# Access Compliance Report

## Public Rights-of-Way

### (Curb Ramps)

Intersection ID: 15542	Main Street: CLANTON_RD	Cross Street: N_CLANTON_TO_S_I-77_RA	Location: NW
ADA ID: 94FFE8464CD0	Ramp Type: Perp	Initial Pass/Fail: Fail	Overall Compliance: No
		Severity Score: 12.5

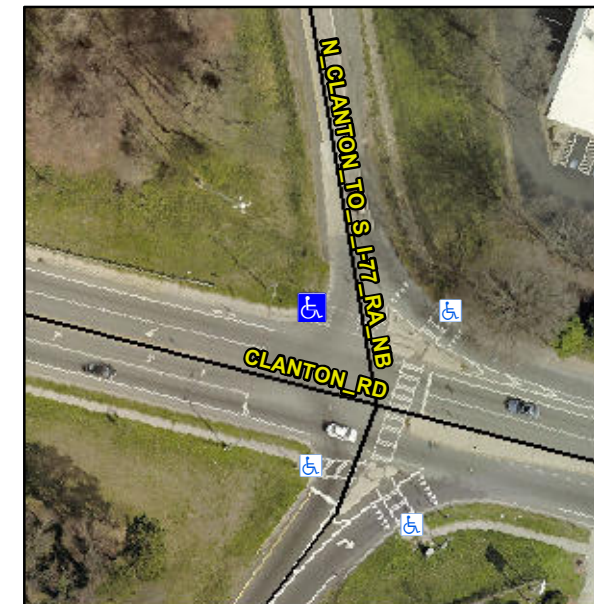
**R304.2.2**

Compliance	Description	Data	Compliance	Description	Data
N/A	Ramp Length (in)	56.0	No	Ramp Slope (%)	8.9
Yes	Ramp Width (in)	48.0	Yes	Ramp XSlope (%)	1.8
N/A	Flare Type LT	N/A	N/A	Flare Type RT	N/A
N/A	Flare Slope LT (%)	N/A	N/A	Flare Slope RT (%)	N/A
N/A	Flare Traversable LT?	N/A	N/A	Flare Traversable RT?	N/A
N/A	Landing Length (in)	N/A	N/A	DWS Provided?	N/A
N/A	Landing Width (in)	N/A	N/A	DWS Contrast?	N/A
N/A	Landing Slope (%)	N/A	N/A	DWS Length (in)	N/A
N/A	Landing X Slope (%)	N/A	N/A	DWS Full Width?	N/A
N/A	Landing Curb? (Y/N)	N/A	N/A	DWS Offset (in)	N/A
N/A	Shared Landing?	N/A			
N/A	Gutter Ponding?	N/A	N/A	Gutter Slope (%)	N/A
N/A	Gutter Lip Ht (in)	N/A	N/A	Gutter X Slope (%)	N/A
N/A	Painted X Walk1?	Yes	N/A	Painted X Walk2?	N/A
	X Walk 1 Direction	To SE		X Walk 2 Direction	N/A
N/A	X Walk 1 Width (in)	110.0	N/A	X Walk 2 Width (in)	N/A
	X Walk 1 Slope (%)	2.0		X Walk 2 Slope (%)	N/A
	X Walk 1 X Slope (%)	1.6		X Walk 2 X Slope (%)	N/A

**Remove & Replace Entire Ramp.**
